Amended Map 5g

Coastal Access - Cleveleys to Pier Head Liverpool - Natural England's Proposals
 Report CPH 5: Southport beach car park to Cabin Hill NNR
 (See maps CPH 5g & CPH 5h for further detail on trail alignment and infrastructed)

Map CPH 5j: Raven Meols Hills LNR area: Coastal Margin
 detail on trail alignment and infrastructed)

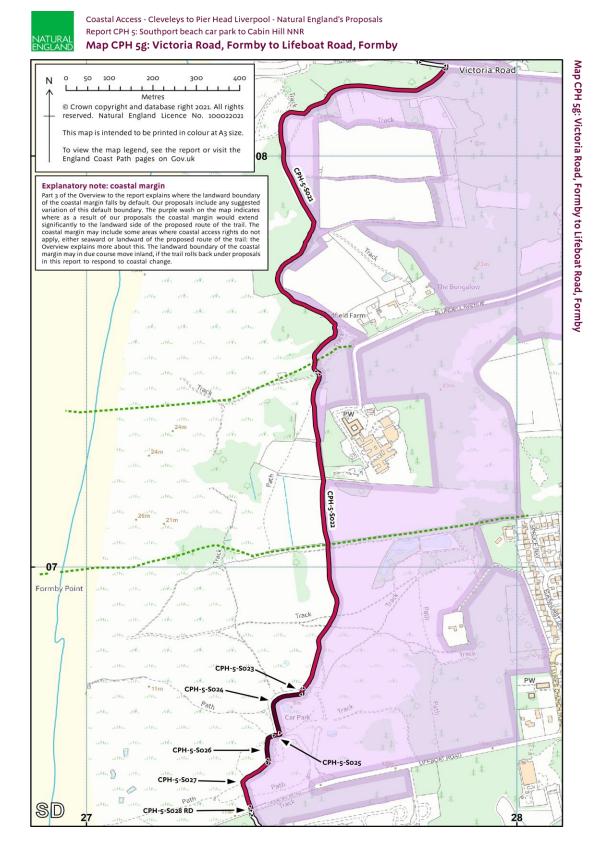
Amended map 5j

This modification removes one field from the coastal margin. Natural England acknowledge in representation MCA/CPH5/R/2/CPH1674 that the inclusion was a mapping error.
